City of Salmon Arm Development and Planning Services Committee

Tuesday, May 19, 2020 8:00 a.m. By Electronic means as authorized by Ministerial Order M139

Development Permit No. 424 (Neighbourhood Commercial)

Development Permit Application - Design Rationale

DRAWN BY DATE: May 2020 SCALE 1:150 AVEX APPENDIX 4: Site & Building Plans PROJECT: 19-618 Back in Nature - Commerical Daycare 480 - 30th Street S.E. Salmon Arm, BC DRAWING TITLE SITE PLAN

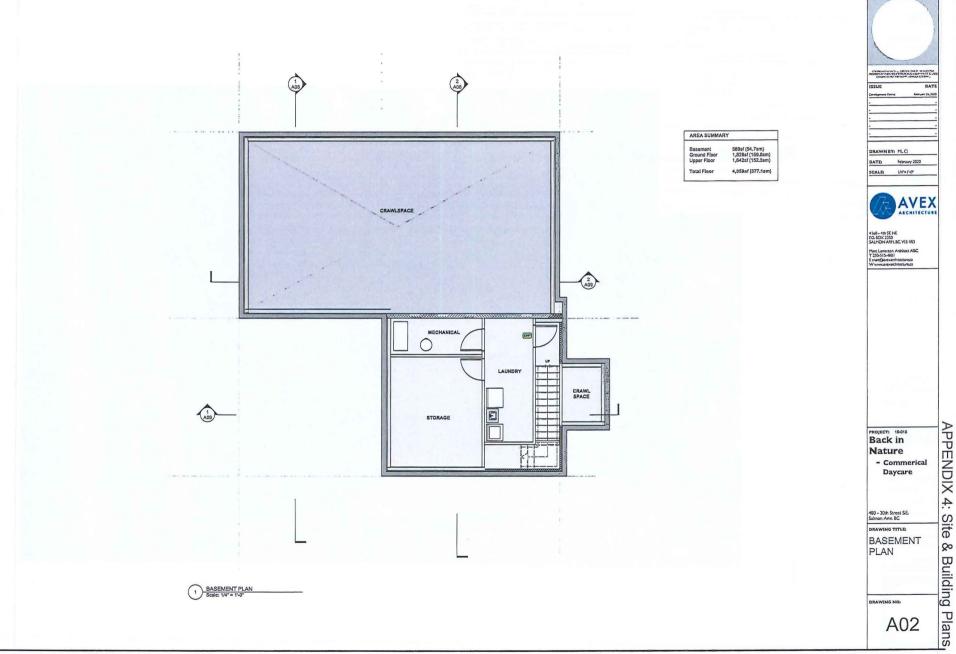
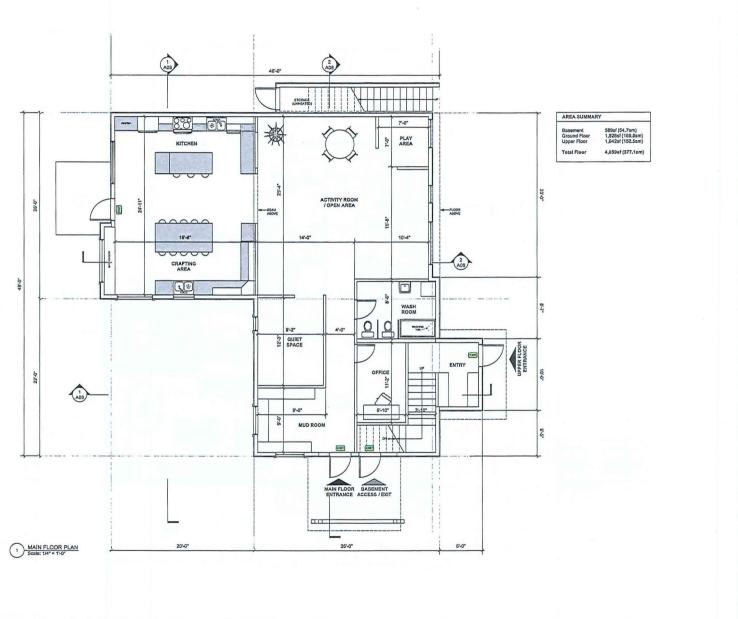
The site plan (Appendix 4) shows the exit on City property at 4.5 metres in width. The Engineering Department requests this egress be widened to 8 metres as this would be a shared access with City property and must accommodate commercial two-way traffic. The applicant is agreeable to widening the access to 8 metres.

The Engineering Department recommends that the requested variance to waive the requirement to provide hard surfacing be denied due to operations and maintenance concerns.
